# insider info.

## Shifter Rattle

1996 Legacy Spacer

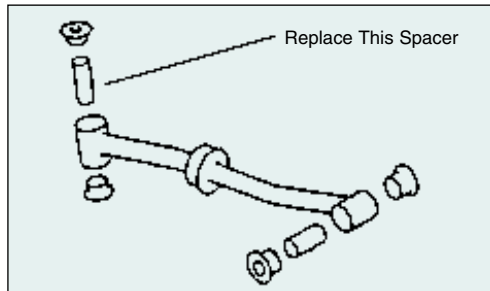
If you encounter a shifter rattle complaint on a 1996/97 Legacy Outback or on a 1998 Forester, the necessary parts are available to correct this symptom.

For the 1996 Legacy Outback, order a modified spacer, P/N 35045AC040.
